## ***Pierre Auger Observatory***

# **Surface Detector Electronics Upgrade UUB Pre Prototype Production Report**

*UUB Model version:* SDE-002-002-IE00

<i>Document written by:</i> E. Lagorio	<i>verified by:</i> P. Stassi
<i>Institute:</i> LPSC Grenoble	
<i>Date:</i> 24 November 2016	<i>Date:</i> 19 November 2016
<i>ATRIUM Reference:</i> 120770	<i>Project Reference:</i> WP05-LPSC-20D

Figure 52: Cut wires and removed resistors.

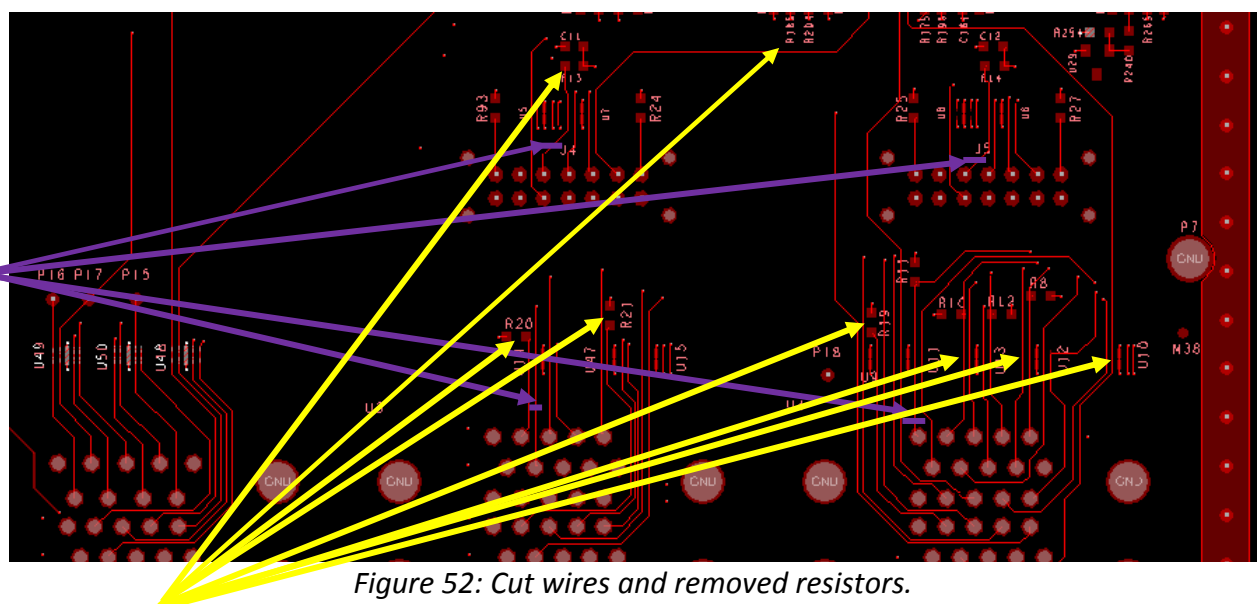
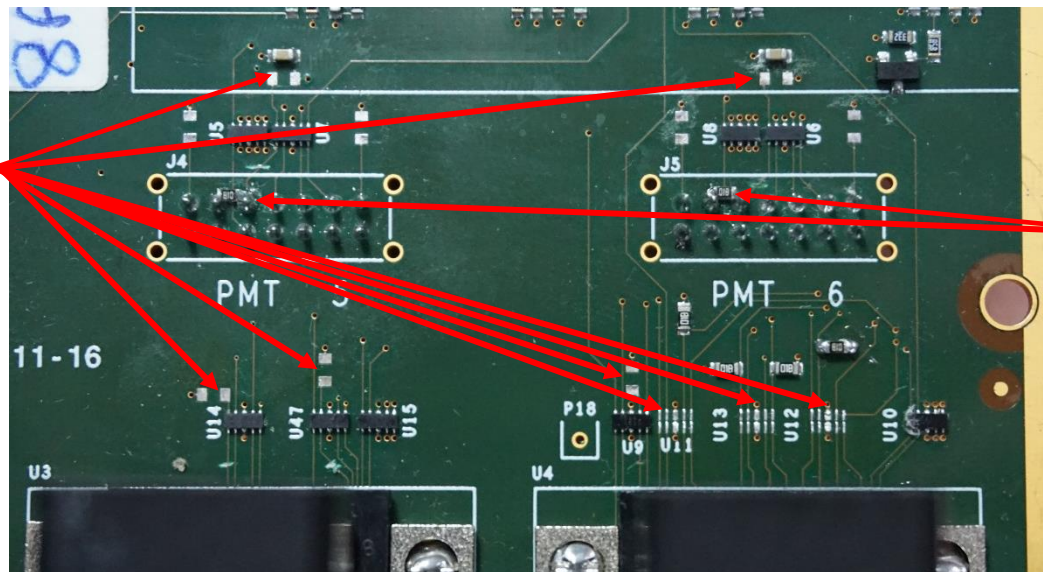
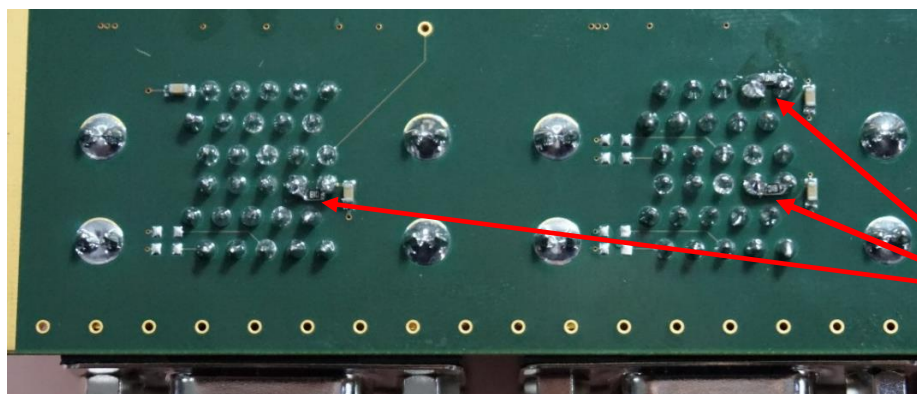
The RCLAMP0524J.TCT ESD component modifies signals for PMT and Tank devices. Wires must be cut, R13, R14, R19, R20 & R21 resistors and U11, U12 & U13 must be removed.

Figure 55: resistors changed on top side.

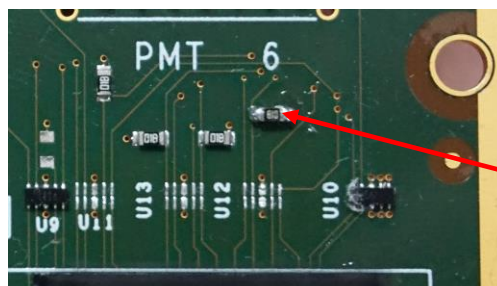
The Temperature sensor power supply adjustment R8 resistor must be changed. The value was 22 kOhms 1% 0603 and it must be 1 kOhms 1% 0603.

Figure 56: resistors changed on top side.

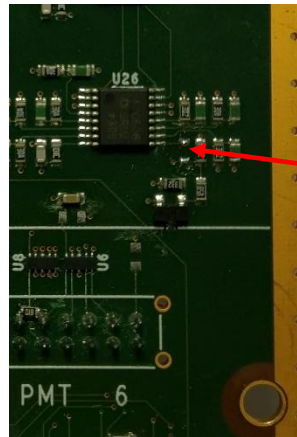
The -3,3 Volts monitoring schema is not conform (NCR n° 2-52). For the Engineering Array the 10 kOhms R242 resistor must be removed.

Figure 57: R29 resistors removed on top side.

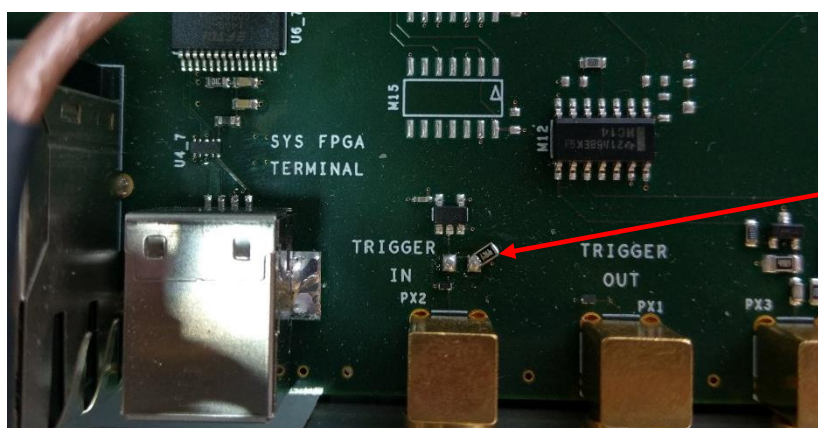
The input 50 Ohms R29 resistor must be removed, but kept on board. There is too many attenuation on the signal.

Figure 58: "RADIO Reset" Wire connection between P15 test point and R155resistor.

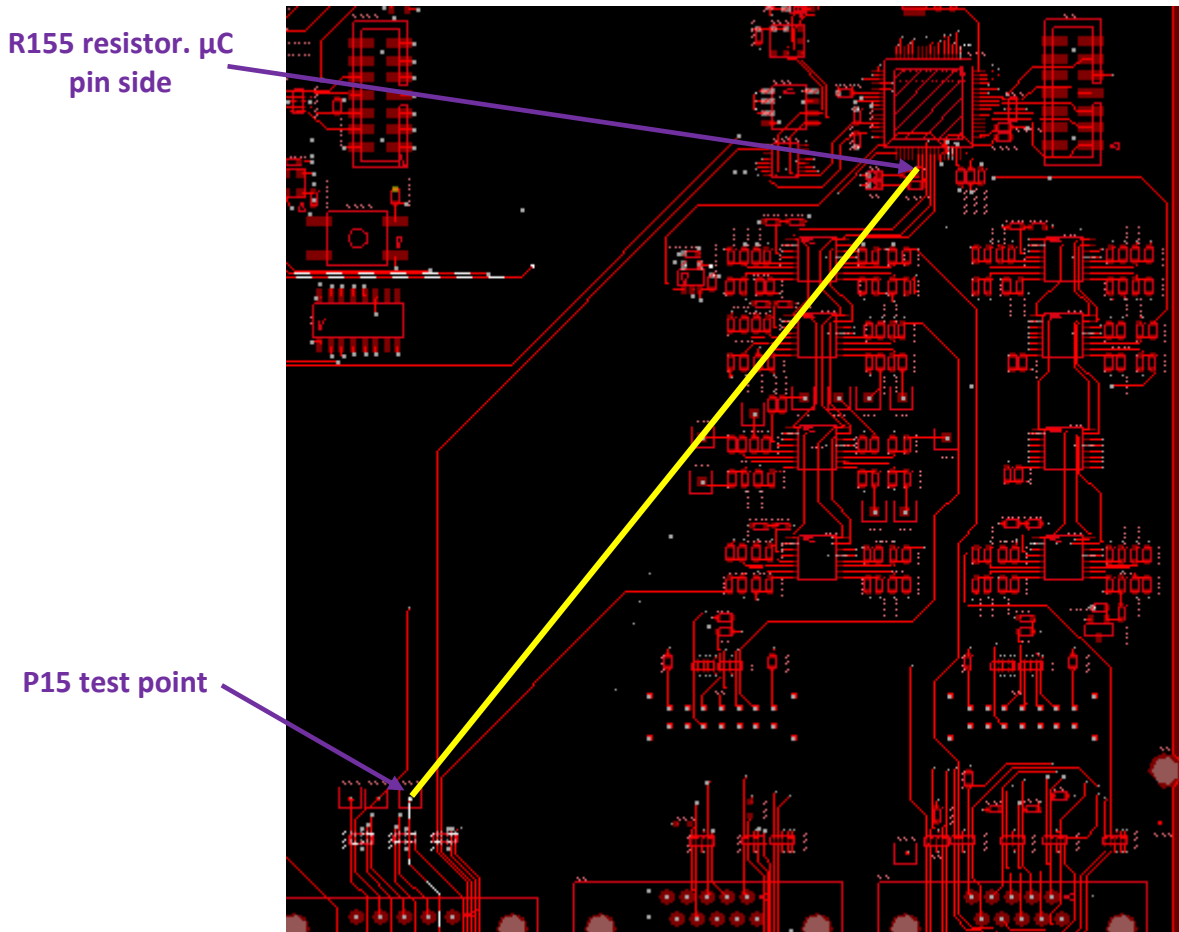
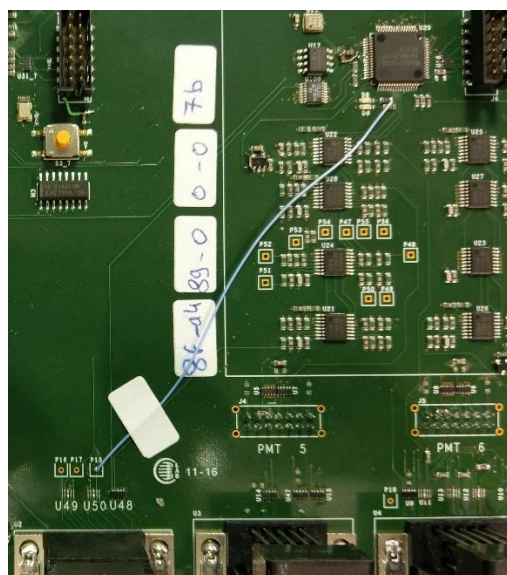
The "RADIO Reset" was managed by FPGA, but now it must be managed by the Slow-Control. It's already managed the UUB's Reset.
